PLAN REVIEW COMMENTS FOR DP-11-22-017374

Town of Bluffton

BUCKWALTER PLACE

SITE DEVELOPMENT PLANS
FOR
BUCKWALTER PLACE
BUCKWALTER PLACE BOULEVARD / LOT 100
BLUFFTON, SOUTH CAROLINA

DRAWING NUMBER
L11

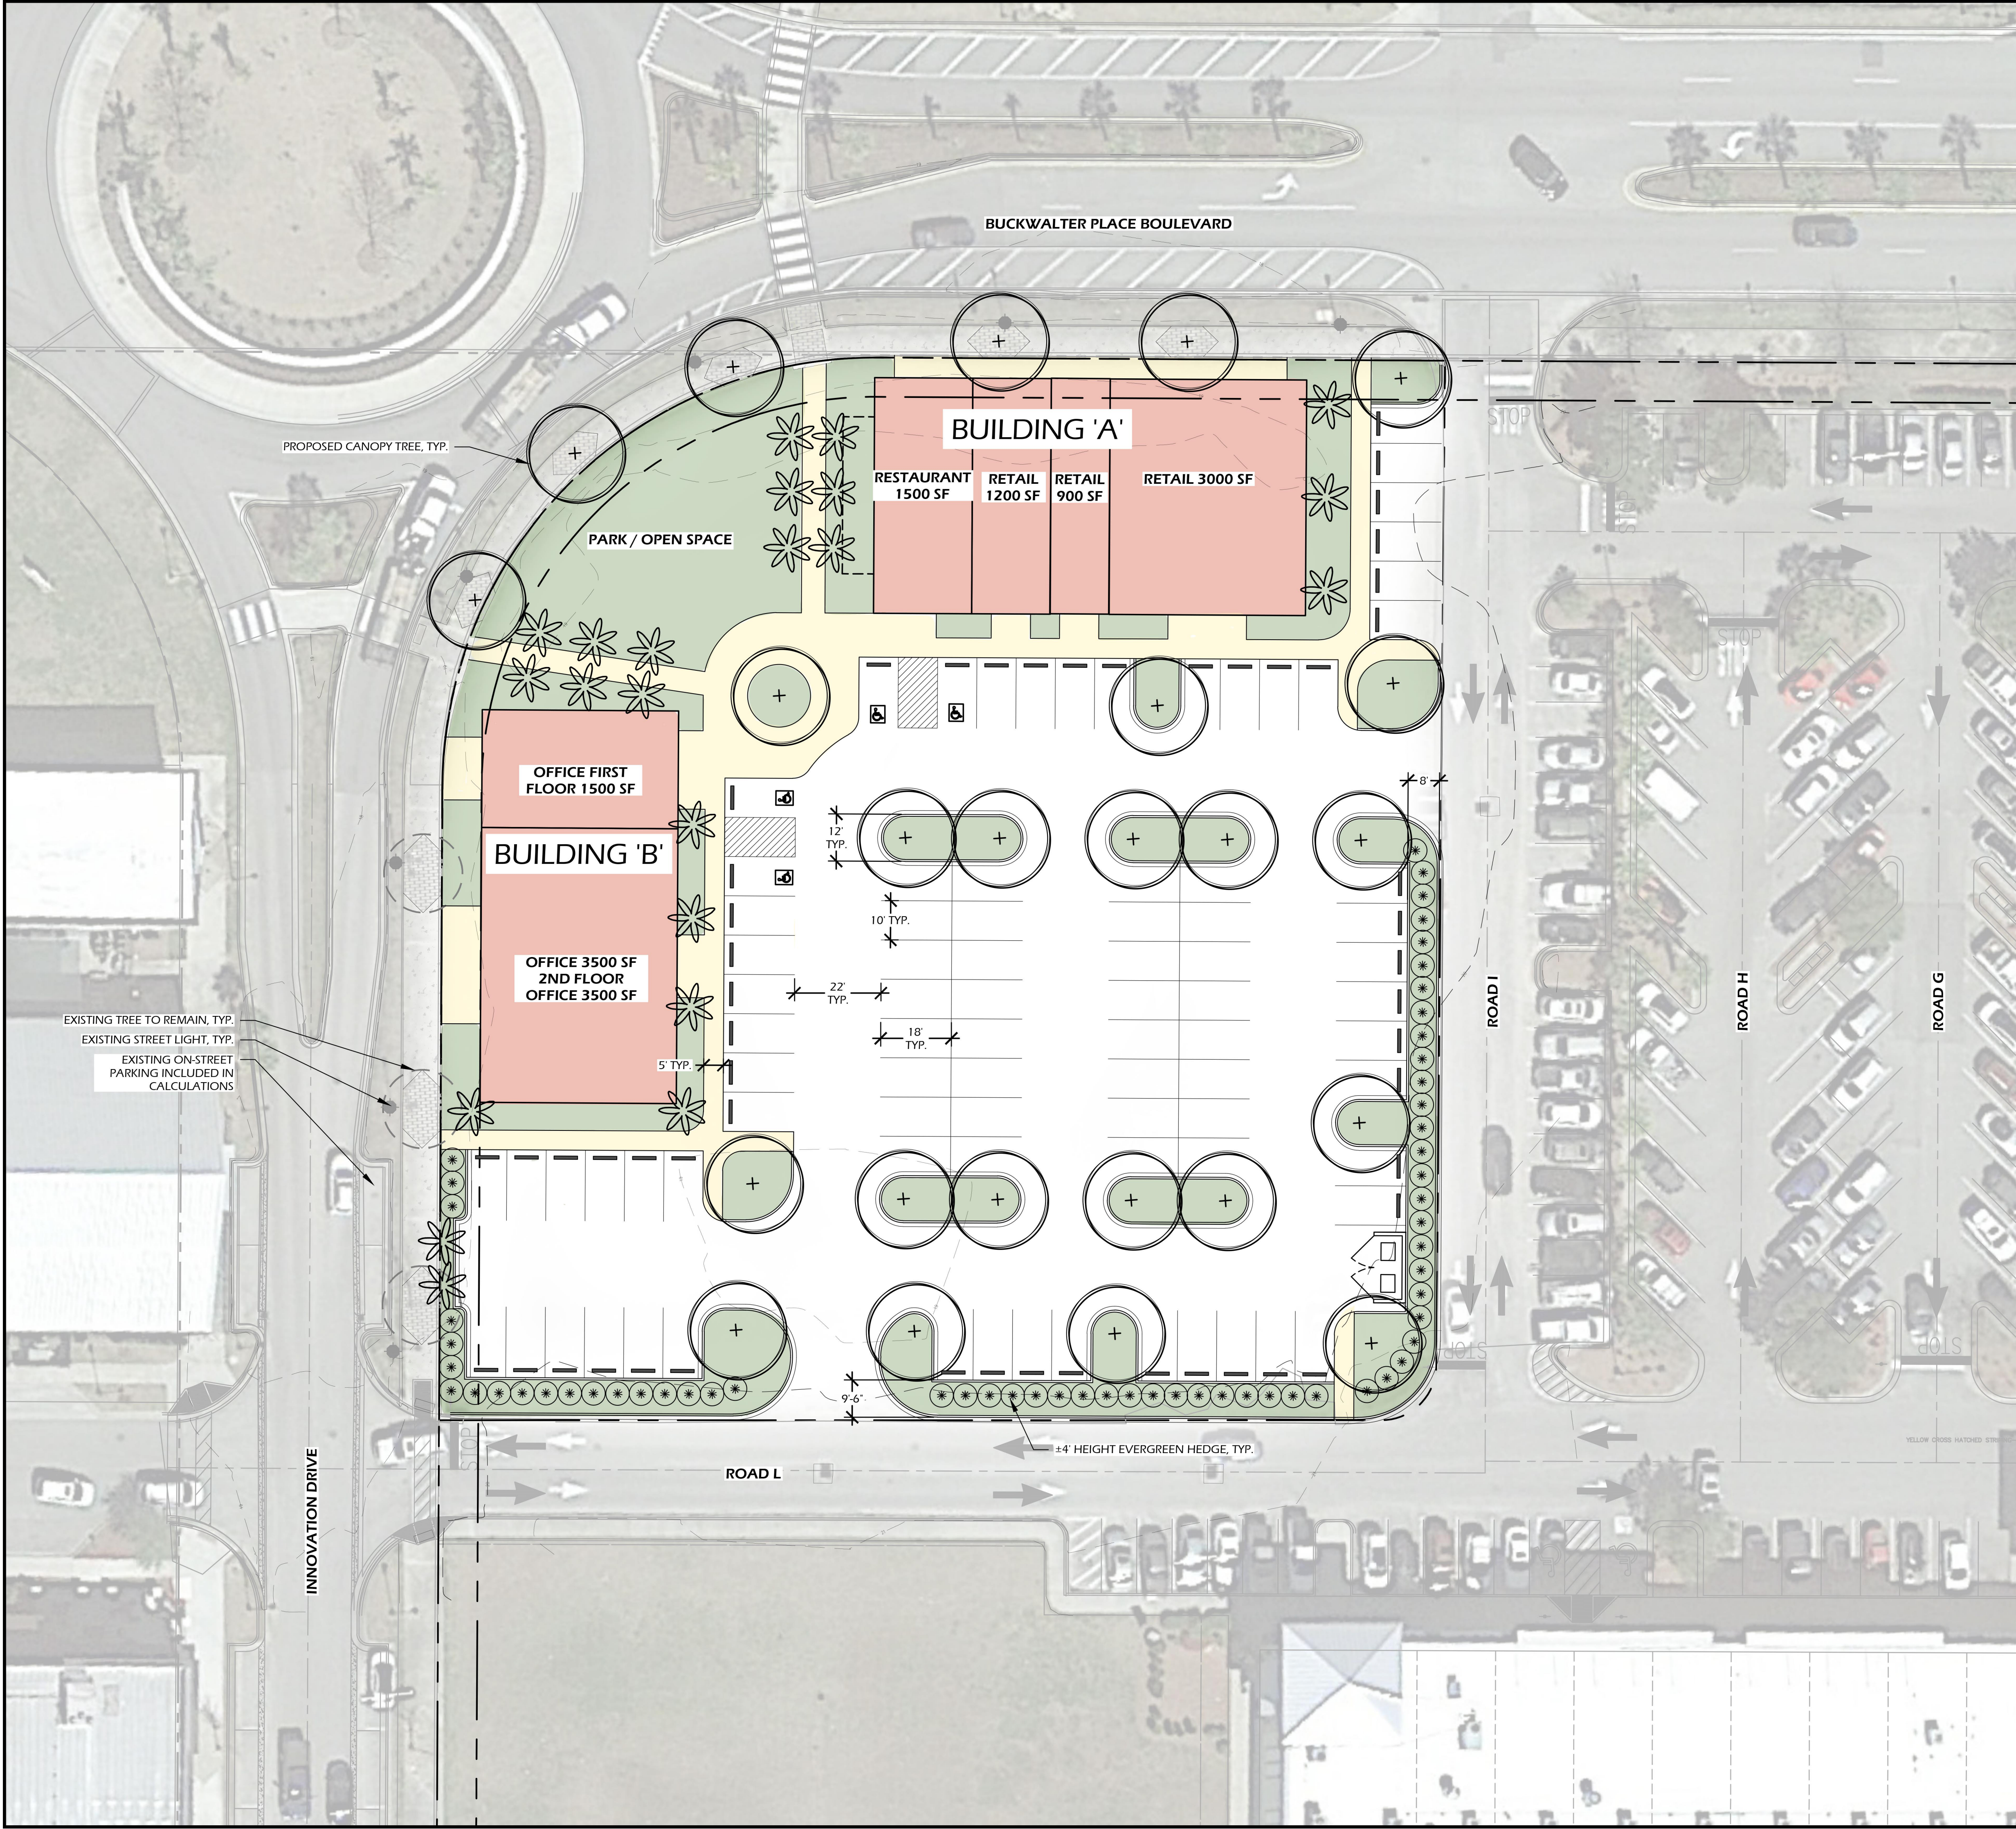
1. If the open space area adjacent to the restaurant is reserved for outdoor dining, the square footage needs to be added to the parking calculations.
2. Clarify the street tree locations. The proposed street trees are currently shown in the middle of the sidewalk. The existing street trees are shown offset to allow for pedestrian circulation.

7. In the narrative, clarify if this will be a phased project.
8. Provide a minimum 5 feet landscape buffer at the end of the parking aisle in the southwest corner of the subject property. The currently proposed landscape buffer in this area appears to be less than 5 feet.

9. Update the open space calculations provided in the data table. The table currently calculates to less than the required 10 percent, however the site plan appears to provide more than 10 percent.

10. Relocate the sidewalk section currently shown in the southeast corner of the subject property to the west side of the southern drive access. This allows the sidewalk section to align with the sidewalk provided on the eastern side of Building 'B'.
